PETITION FOR ADOPTION, AMENDMENT, OR REPEAL OF A STATE ADMINISTRATIVE RULE

Agency responsible for adopting or administering the rule: Washington State Building Code Council

Petition for Repeal of the Provision in the Recently Adopted Commercial Energy Code Requiring On-Site Renewable Energy for Commercial Buildings over 10,000 square feet - (Proposal 21-GP1-078)

Mid-Columbia Average Hourly Prices

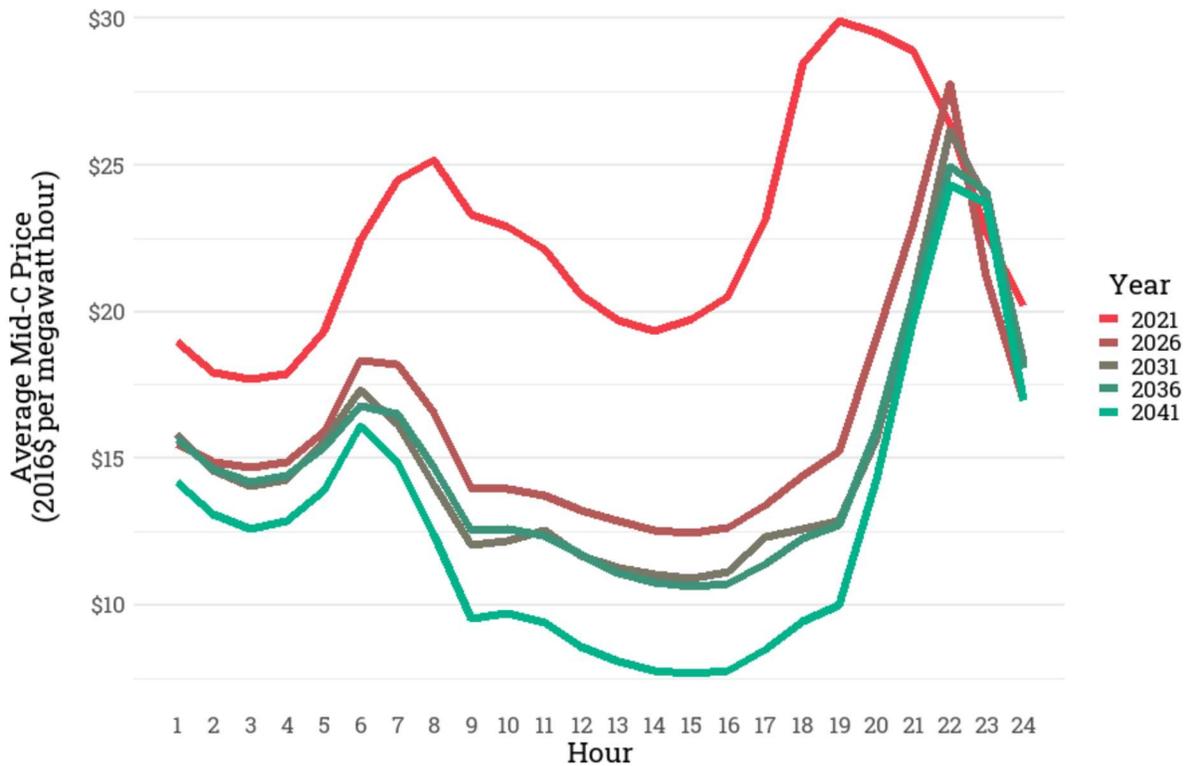
Fortunately, the NWPCC has projected those values during the development of their 2021 Northwest Power Plan and those values are illustrated in the following two graphs.⁵

It is clear from these graphs that the NWPCC expects wide variations in the value of energy between hours, months and years; with 2041 values roughly half of what they were in 2021. Moreover, by 2026 the NWPCC anticipates a significant dip in value of energy during the prime-time period for solar generation (10 am to 5 pm). The projected value is less than \$0.015/kWh; or about 85% less than the \$0.092/kWh estimate provided in the economic analysis.
